# Riva Townhomes

Project No. PRJ14-00023, SDP15-00004

Site Development Permit  
Development Commission Public Hearing  
September 7, 2016

# Shared Use Route on Riva property

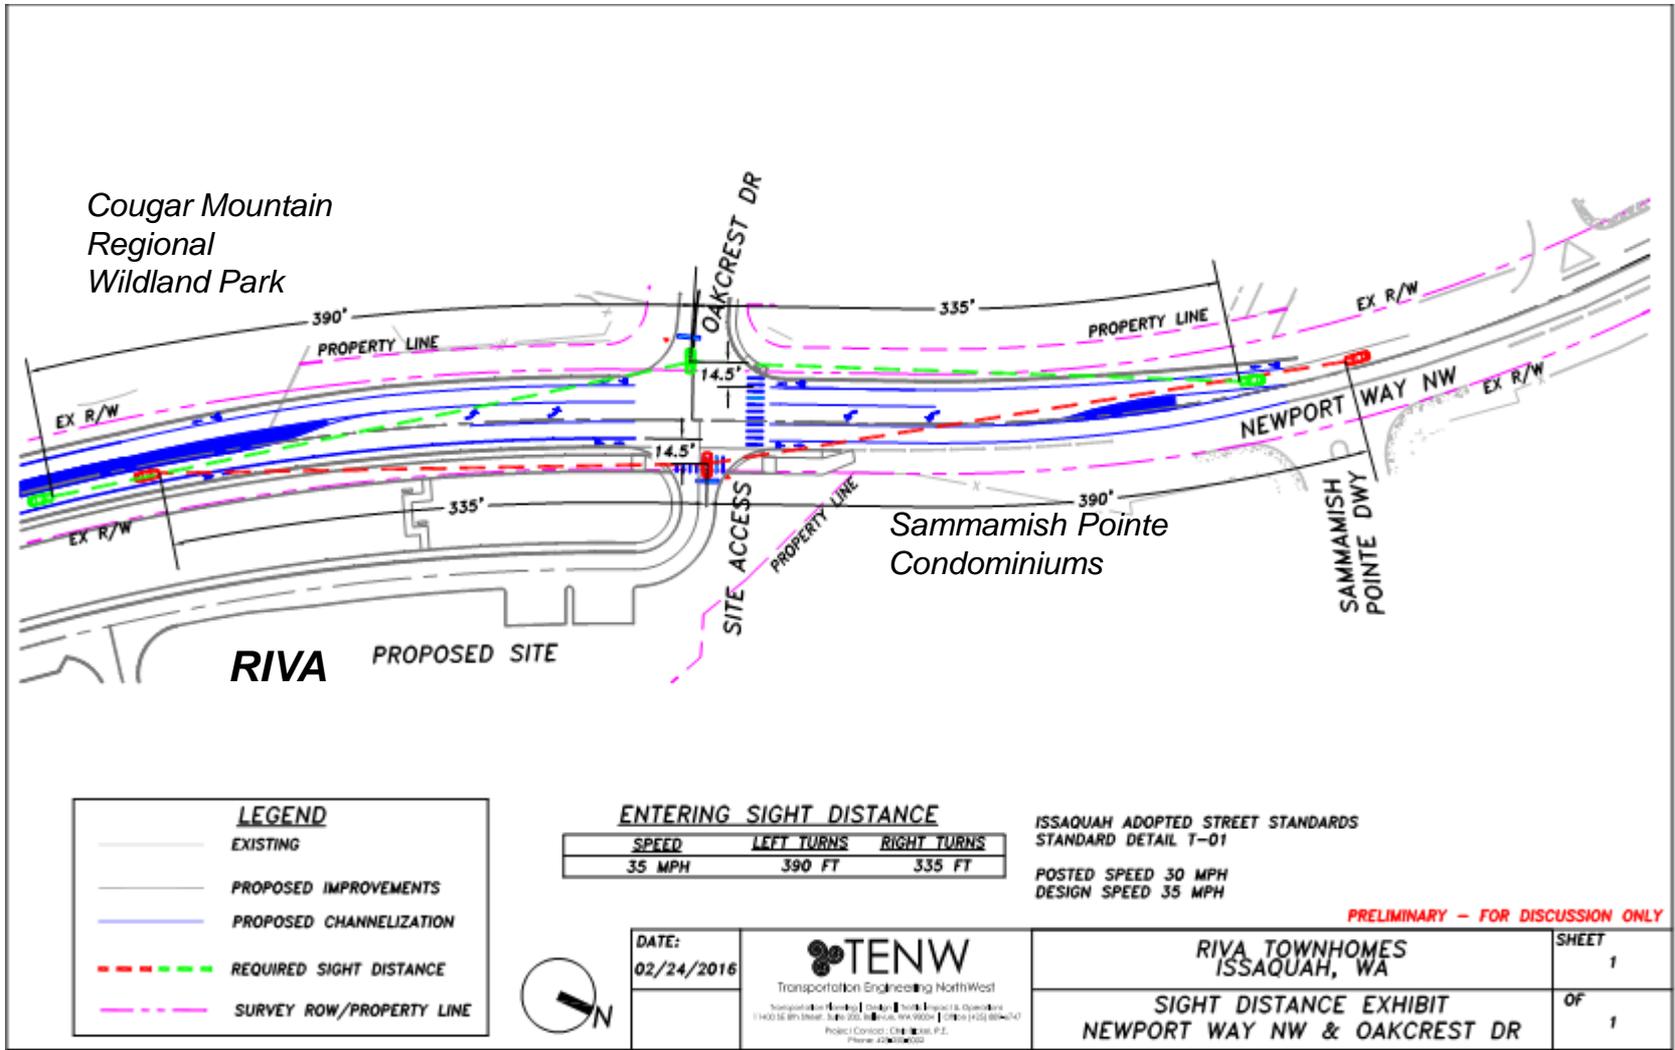
## Replace Condition 9 with new condition:

In lieu of constructing the Shared Use Route,

- pay the applicable Park Impact Fees
- provide a relocatable public access easement, with a width of 20 feet, for the entire length of the Shared Use Route
- Signage

Delete conditions 2.c, 10 and 11

# Newport Way R.O.W. Improvements

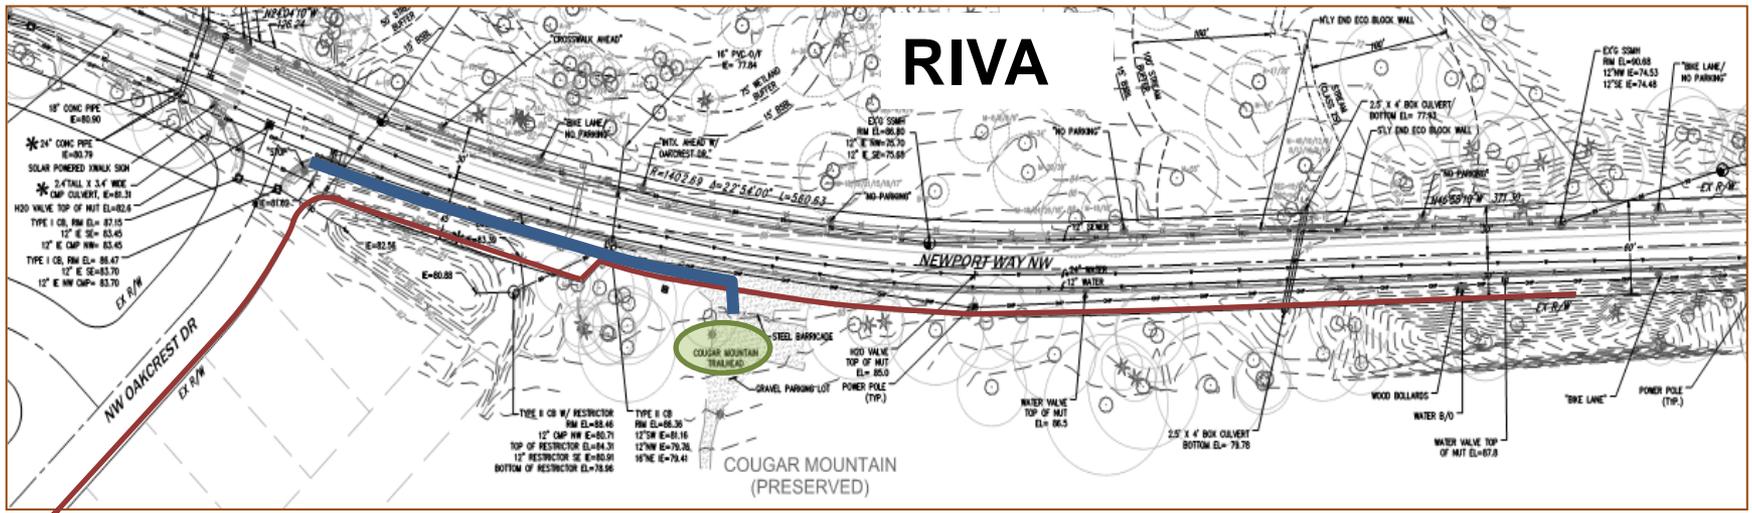
## New condition 29:

The applicant shall provide a 5-foot wide compacted gravel path within the existing street right-of-way on the southwest side of Newport Way NE, opposite side of the street from the proposed development, adjacent to the curb face, extending from NW Oakcrest Drive southeast to the Precipice Bottom Trailhead (aka Cougar Mountain Trailhead). This is required to replace the existing gravel shoulder which would be removed due to project road improvements.

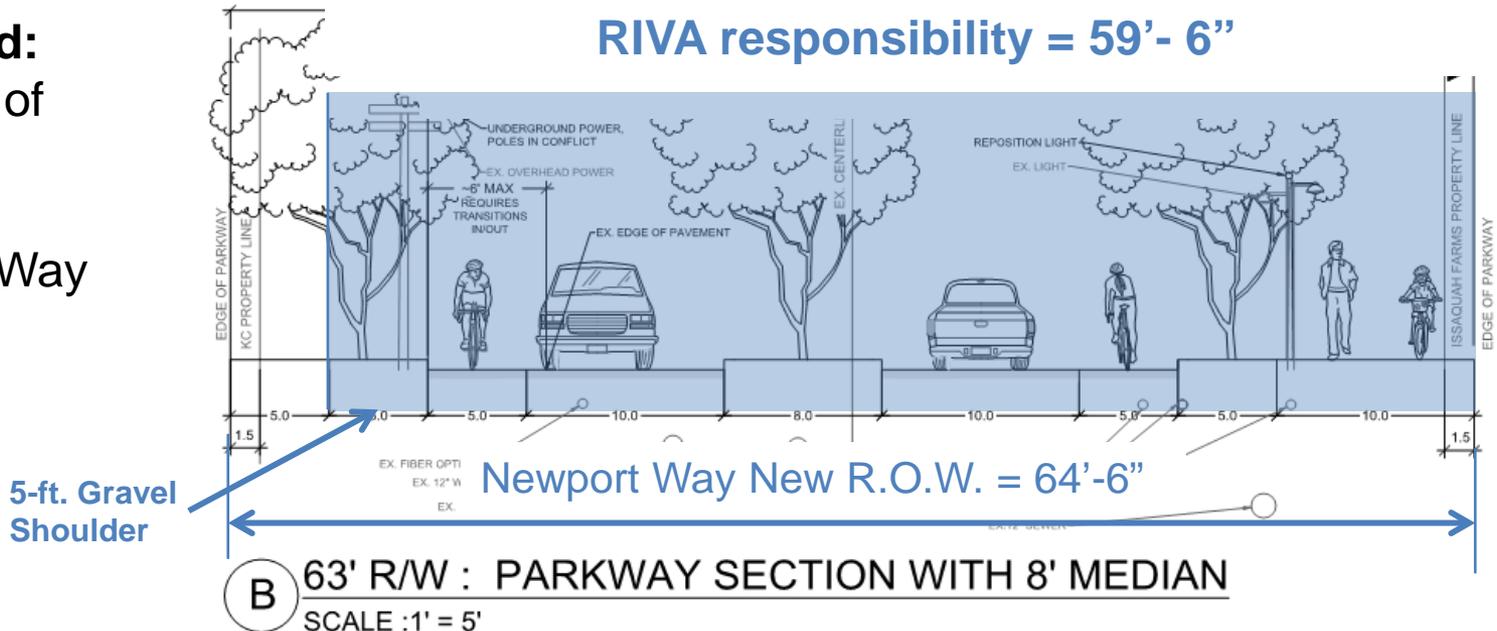
New R.O.W. widths: 63' and 67'

**Proposed:**  
58-ft. out of the 63-ft. r.o.w. of Newport Way
